Planning Appeal Reference: APP/W0530/W/18/3210008

Planning Application Reference: S/4099/17/OL

Smithson Hill Planning Inquiry - Statement of Rupert Kirby, Hinxton Resident

**FIGURE 1 – Data submitted by Hinxton Parish Council – January 2018**

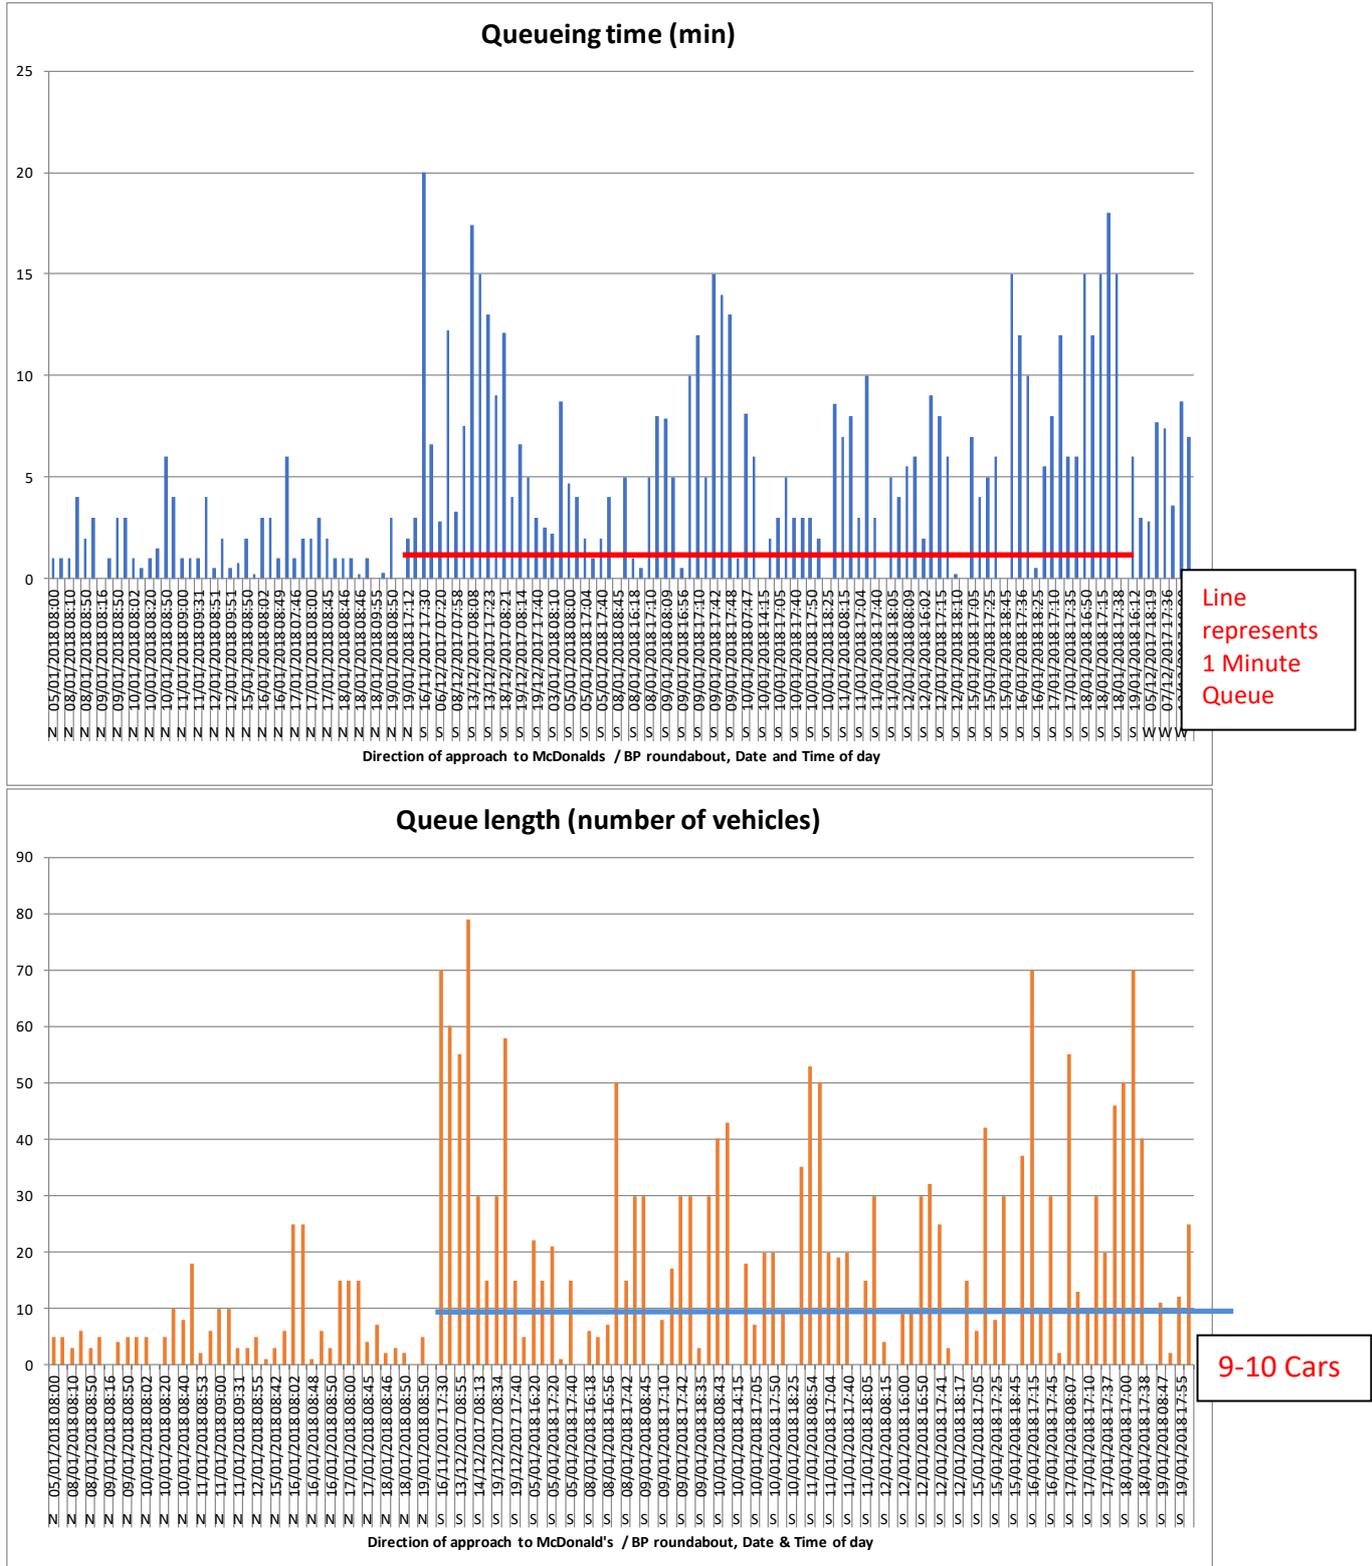
- 1.4. Even with these very modest recorded queues, paragraph 10.24 acknowledges that the roundabout is at capacity in the morning peak, and close to maximum capacity during the afternoon peak.
- 1.5. Unfortunately those observed results, obtained on a single day, are gross underestimates of the actual situation. The reality is shown in the tables on the following pages. Figure 1 is data originally submitted by Hinxtion Parish Council in January 2018 and Figure 2 shows more recent data submitted in May 2019. I have added lines on the graphs to show the baseline data figures that the traffic analysis relies upon.

- 1.7. More importantly, the model used by TPA in their analyses, when applied to the A505/A1301 junction, grossly underestimates the long queues and significant delays that are currently experienced on the northbound A1301 on an almost daily basis.
- 1.8. Table 10.8 (from TN04) below shows this as the model translates the queues into waiting times of around **1 minute** on the A1301 (south) as highlighted. If this were really the case, it would seem surprising that 121 people would take the time to write in to the council about the state of the current traffic.

### 1. Googlemaps Route to Sawston Medical Practice – 17.57, Monday 28<sup>th</sup> January 2019.

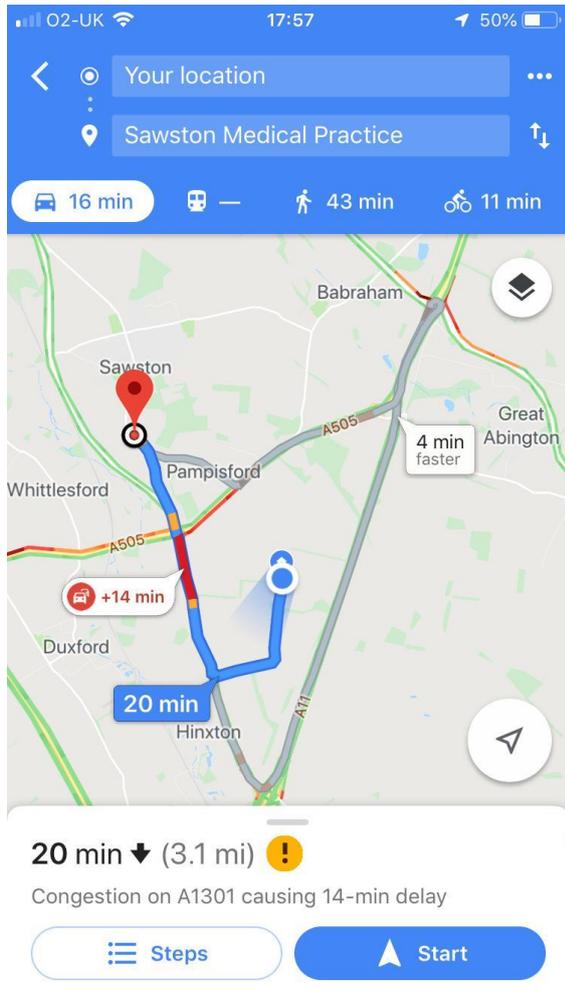
This situation demonstrates:

1. There is a 14 minute queue to get the roundabout, and my experience is that queueing times are invariably underestimated by Googlemaps.
2. The recommended route is to go south away from Sawston, past the Genome campus, up the A11, around the A1307 roundabout, back onto the A505 and then to cut through the village of Pampisford to avoid the congested McDonalds roundabout. This would save 4 minutes, assuming the queue time is correct.
3. The route is 9 miles - 3 times further than the most direct route via the A1301 McDonalds roundabout, causing a significant environmental impact.

## 2. Googlemaps Route to Royston – 08:03, Monday 4<sup>th</sup> March 2019.

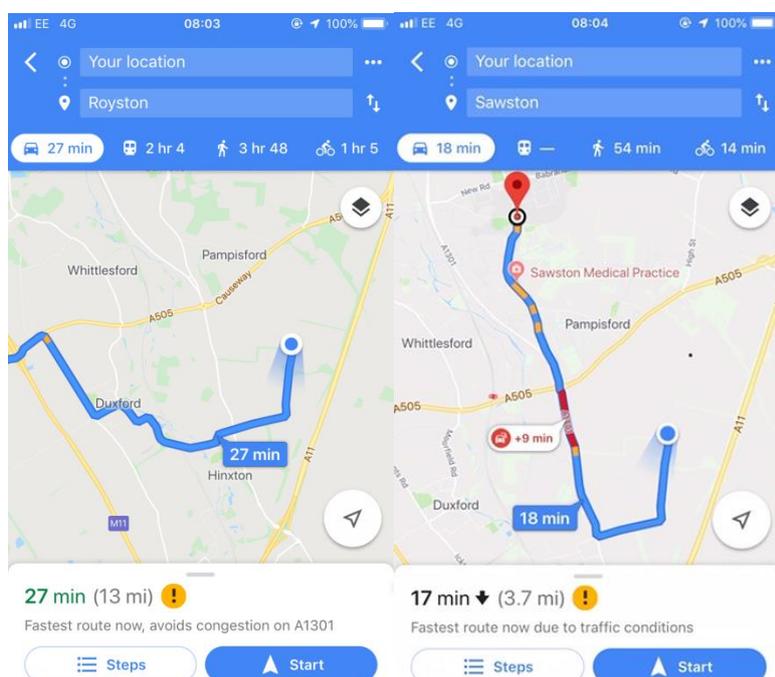
This example demonstrates that Googlemaps was recommending cutting through Hinxton and Duxford to go west onto the A505. The comment on the recommended route states “**Fastest route now, avoids congestion on the A1301**”.
